HUNTINGTON BEACH PLANNING DEPARTMENT

PLANNING APPLICATION NO. PLANNING APPLICATION NO. 2008-0050

**ENVIRONMENTAL CHECKLIST FORM
CITY OF HUNTINGTON BEACH
PLANNING DEPARTMENT
ENVIRONMENTAL ASSESSMENT NO. 2008-011**

Narrative for 612-620 Pacific Coast Highway
PACIFIC VIEW

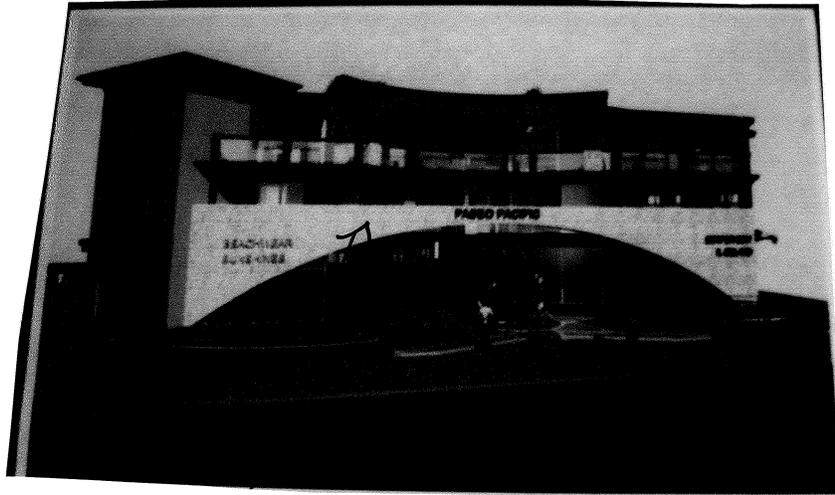
The "ARCH" is the worst part of this building. It has a Cave like Feel to the entry instead of being inviting and warm.

The "ARCH" in the design of this commercial does not fit any of the city design guideline styles of other commercial properties in the immediate area. There is a theme downtown which gives the downtown area a cohesive look and it should be adhered to. Looking at main street you can see how it is developing into a California resort Tuscan style. This building DOESN'T FIT IN TO ANY STYLE.

Not only that but we have 2 million dollars residential homes that surround the building, and now we would have to look at a 1970's unattractive Motel style tall building.

Please work with the architect on this design for some improvements.

BACK BALCONIES/ PARKING AREA

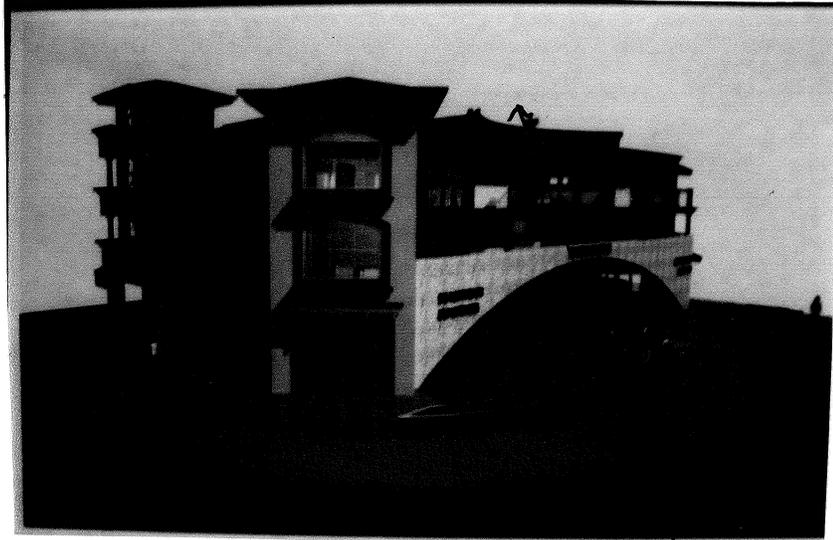
Balconies look very plain with the front dividers , and do not fit with the Design guidelines of the city. It would look better if the balconies were broken up with planters or architectural design features. The way it looks now it looks more like a motel without style.

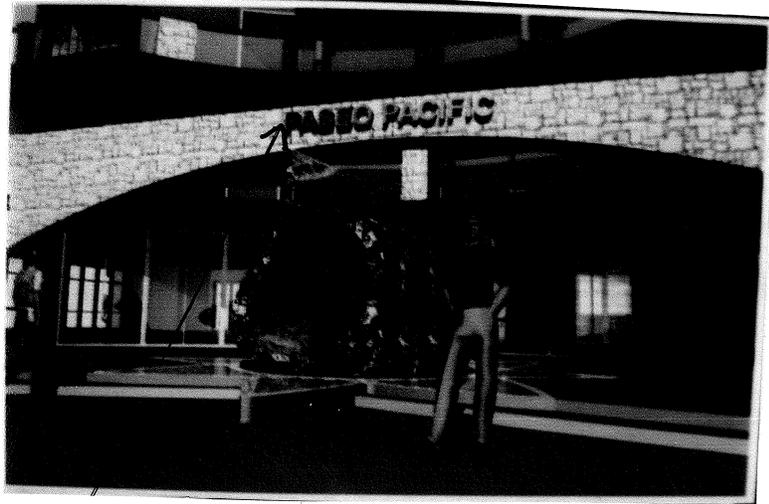
The front of the building has a **real lack of landscaping and greenery features.** Hopefully there is a plan in that area.
